# CONOCO DOLOMITE HOT GAS CLEAN-UP SYSTEM

Earl D. Oliver and Konrad T. Semrau Stanford Research Institute Menlo Park, California 94025

This report analyzes a proposal that EPA sponsor a large-scale pilot plant to develop the Conoco (formerly Consol) Dolomite Hot Gas Clean-up system. The report includes a history of the prior development program, the technology involved comparisons with competitive technologies in regard to technical feasibility, potential efficiency, and environmental benefits. Future funding implications are explored. The potential benefits in economy and efficiency of energy conversion are judged to be substantial, but the cost of development is high. The expected cost of the pilot plant program may be greater than funding ability. The current laboratory program should either be continued or should be terminated in a way that will insure that the knowledge already gained is retrievable.

The EPA has been supporting laboratory and theoretical development work on the Conoco (formerly Consol) Dolomite Hot Gas Cleanup system. The results have been encouraging, and Conoco Coal Development Company has proposed expanding the program to include development on a pilot p

FIGURE 1 PROPOSED CONOCO PILOT PLANT

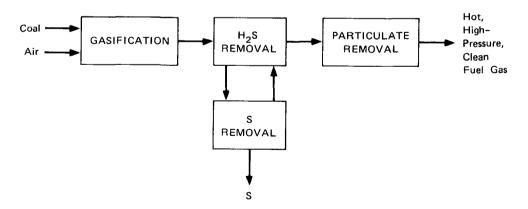
SRI concludes that there is little chance of meeting the projected time and cost schedule with the Conoco process in its present state of development. This conclusion is based on a comparison of the requirements of the proposed pilot plant program with those of the analogous program to develop the  ${\rm CO}_2$  Acceptor Coal Gasification process. The proposed program includes four separate process developments--gasification, desulfurization, particulate and alkali fume removal, and liquid-phase Claus sulfur recovery--requiring six developmental reactors. The  ${\rm CO}_2$  Acceptor pilot plant includes only two developmental reactors. An additional basis for the conclusion is the difficulty of solving mechanical and chemical problems inherent in the Conoco hot gas cleanup process.

Experimental results of the Conoco process to date have been promising but have been more exploratory than definitive. If the decision is made to continue support, the question will remain as to the best way to proceed. The Conoco proposal might make the process available at the earliest date, but this is not certain because nonoptimal designs in large-scale equipment might require major modifications.

A more orderly program would start with construction and testing of a reliable pilot-scale gasifier, presumably funded by ERDA. Concurrently, further small-scale tests would be made on the desulfurizer-regenerator system and the liquid-phase Claus reactor. In addition, process variable studies, testing of various dolomites, and particulate removal studies would be carried out on a small scale. In these studies, reliability would be shown by closing material balances, especially those involving sulfur and alkali compound fumes.
